TPB Ref.: A/NE-TKL/845

Proposed Temporary Open Storage of Construction Materials with Ancillary Facilities & Associated Filling of Land for a Period of 3 Years at Lots 967 (Part) & 979 (Part) in D.D.82, Ping Che Road, Ta Kwu Ling, N.T.

Our response to the comments of Transport Department is found in below:

Figure 2

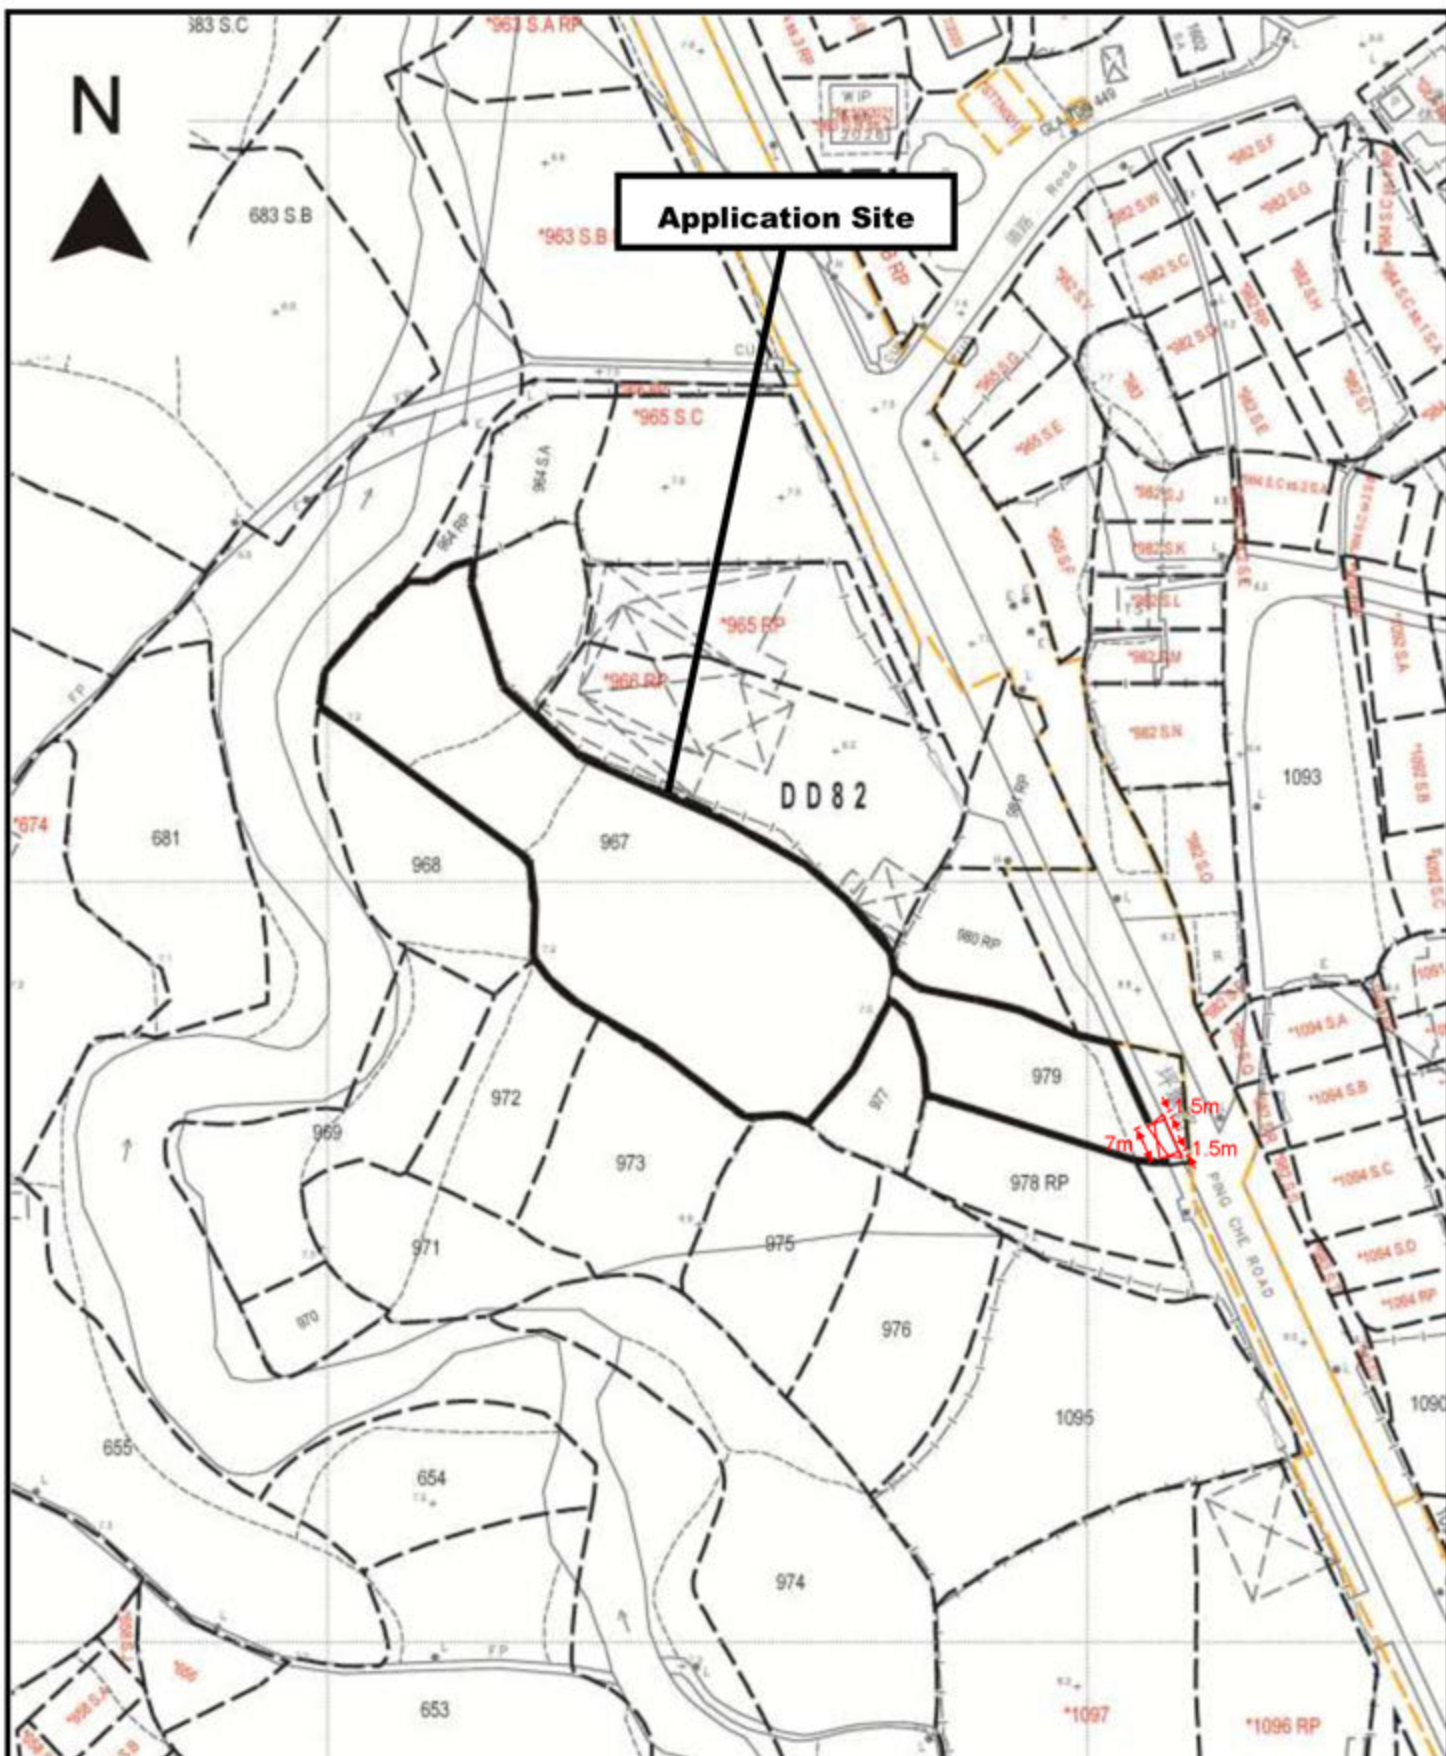
DLO/N's comments	Applicant's response
LandsD has adverse comments on the application; • the application site comprises Old Schedule Agricultural Lots held under the Block Government Lease which contain the restriction that no structures are allowed to be erected without the prior approval of the Government; • the following irregularity covered by the subject planning application has been detected by LandsD: <u>unauthorised structures within Lot 967 in D.D. 82 covered by the</u>	The unauthorized structures within the Lot 967 in D.D.82 will be removed. The applicant will apply for short term waiver (STW) before the erection of the proposed temporary structures as shown in the proposed layout plan attached to the current planning application.

<u>planning application</u> there are unauthorised structures on Lot 967 in D.D. 82. The lot owners should immediately rectify the lease breaches and LandsD reserves the rights to take necessary lease enforcement action against the breaches without further notice; and • if the planning application is approved, the lot owners shall apply to LandsD for a Short Term Waiver (STW) to permit the structures erected/to be erected within the private lots concerned. The application for STW will be considered by the Government in its capacity as a landlord and there is no guarantee that it will be approved. The STW, if approved, will be on whole lot basis and subject to such terms and conditions including the payment of back-dated waiver fee and administrative fee as considered appropriate to be imposed by LandsD. Besides, given the proposed use is temporary in nature, only erection of temporary structure(s) will be considered.

Figure 6

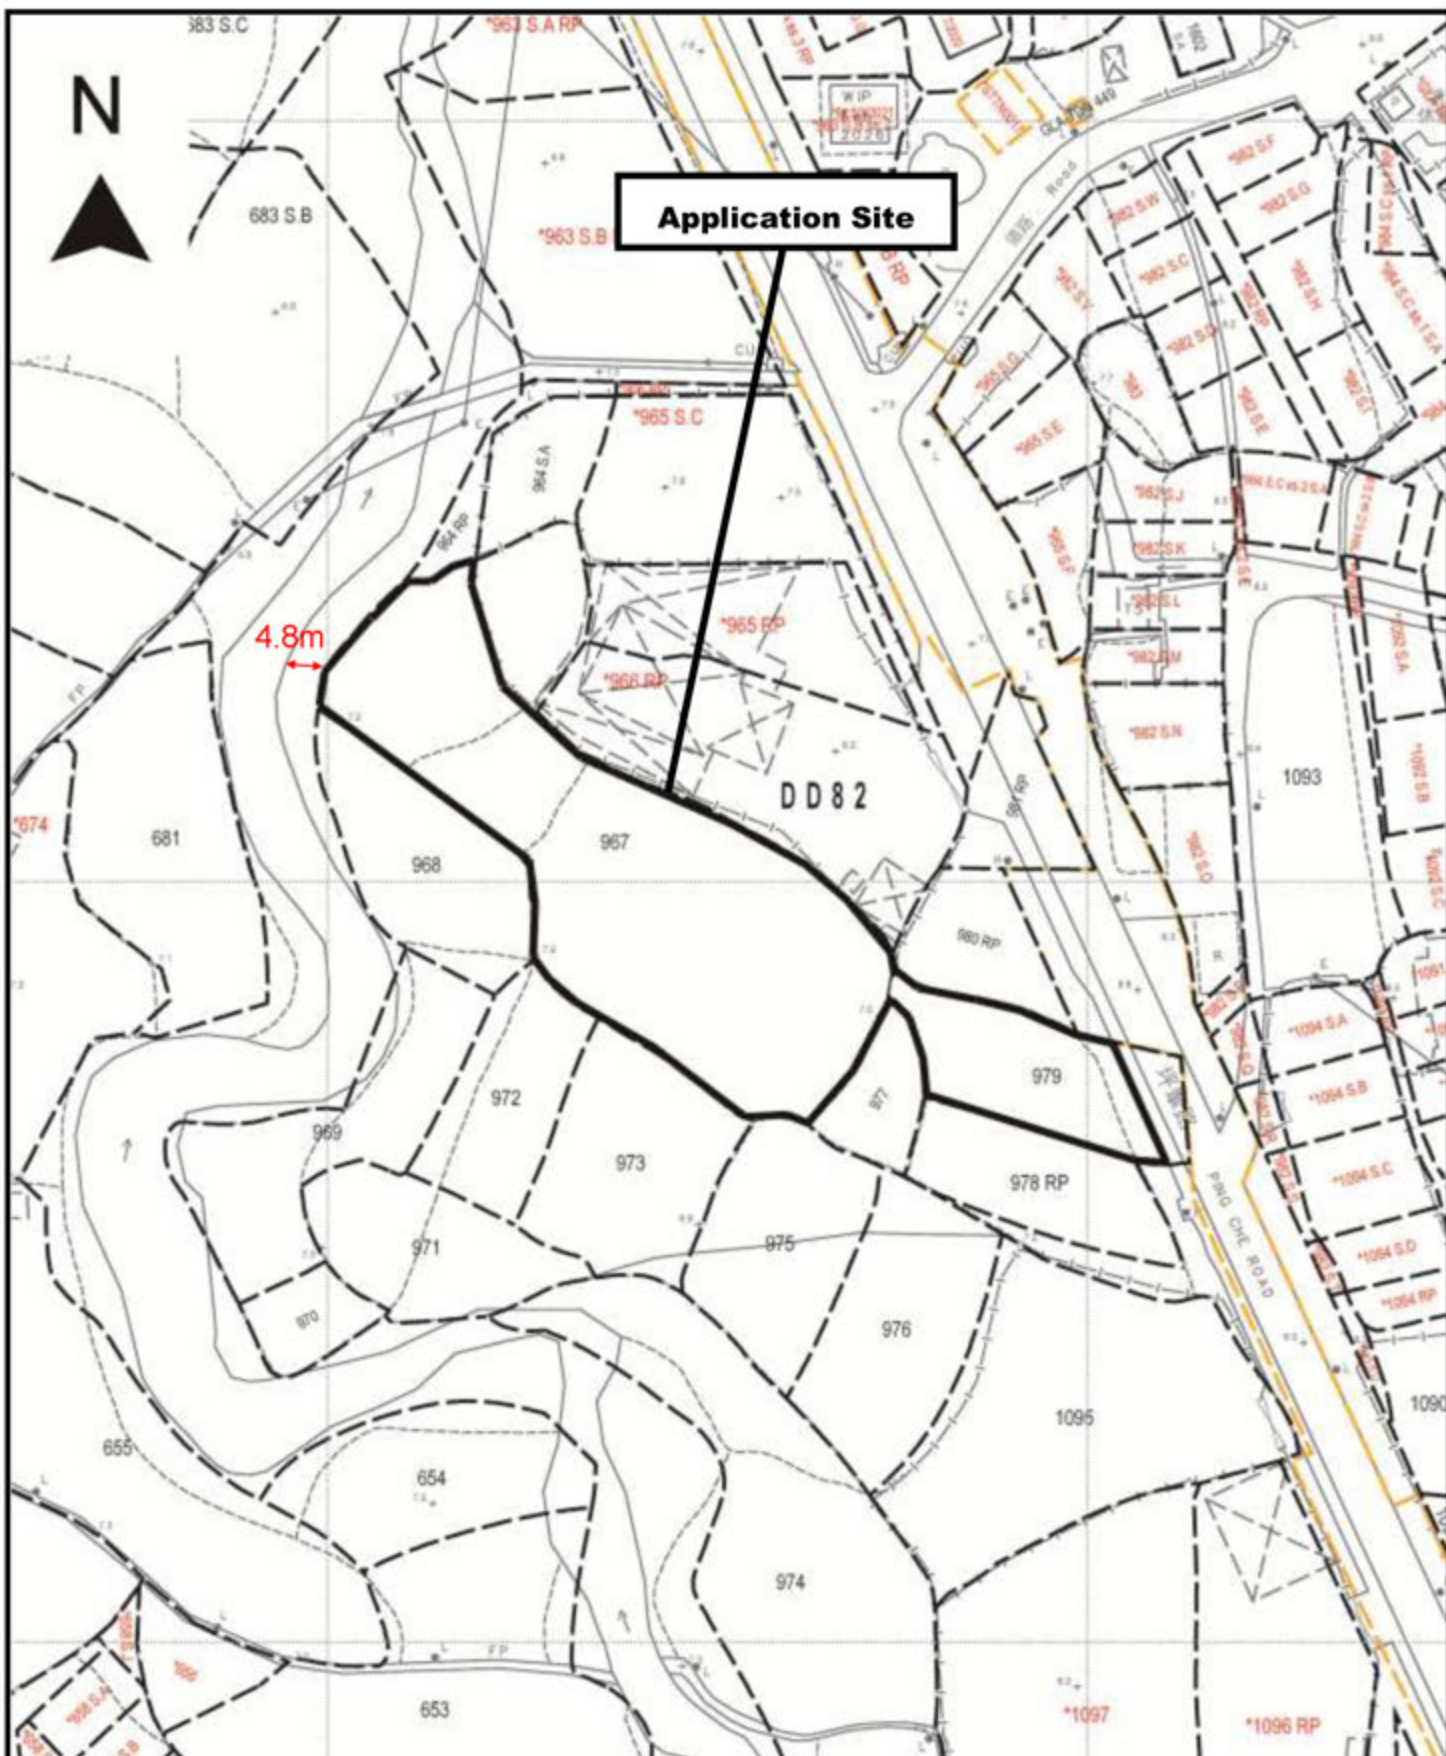
Transport Department's comments	Applicant's response
the applicant should demonstrate the satisfactory manoeuvring of the goods vehicles entering and exiting the application site, manoeuvring within the application site and into/out of the parking and loading/unloading spaces, preferably using swept path analysis;	Noted. Swept path analysis is conducted to demonstrate the manoeuvring of a MGV/HGV entering and exiting the subject site, maneuvering within the subject site as well as moving into / out of the loading/unloading space. Please refer to Figure 4 & Figure 5 attached for details. The updated layout plan is attached because the location of the 2 parking spaces and 1 loading/unloading space has been slightly moved.
the applicant should provide a proposal on the vehicular access arrangement including the run-in/out design for the vehicles leaving/entering the proposed use;	Noted. Please refer to Figure 6 attached for the proposed vehicular access arrangement.
